Statement of Response to An Bord Pleanála Opinion

Proposed Strategic Housing Development

Dunlo & Pollboy, Ballinasloe, Co Galway,

ABP-312236-21

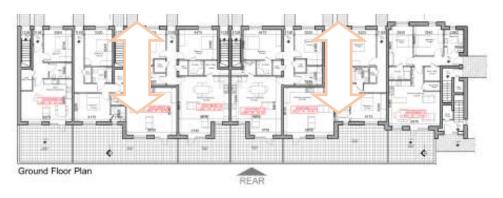
(d) Further justification / investigation of the public open space strategy and quantum and quality of communal open space. Further consideration of a legible and connected green (biodiversity) network, ideally providing a continuous biodiversity corridor through the site.

The provision of quality community space has been given full consideration in the refined scheme. A comprehensive landscape design is set out in the **Landscape Design Report** and associated drawings which had been prepared by Cunnane, Stratton Reynolds in support of this application.

Consideration has been given in the landscape design to the provision of a legible and connected biodiversity network, by the preservation of the existing internal mature hedgerow boundary in conjunction with the protection of mature edge boundaries along the southern and western side of the development site, as indicated above.

Block B1-13

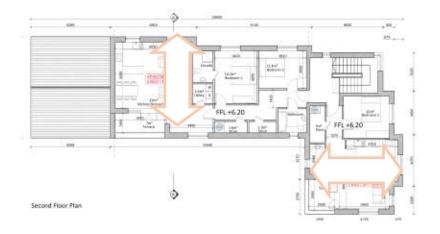
(a) Further consideration and / or justification of the documents as they relate to future residential amenity, having particular regard to the proportion of single aspect and north facing units and daylight and sunlight access. Particular regard should be had to the requirements of the Sustainable Urban Housing Design Standards for New Apartments Guidelines (2020) Section 3.16 – Section. 3.19 in relation to the dual aspect ratio and north facing units.

RESPONSE: A total of 100% of the apartment and duplex units to be provided within the development have been designed with dual aspect ratio, as demonstrated on the key plans below.
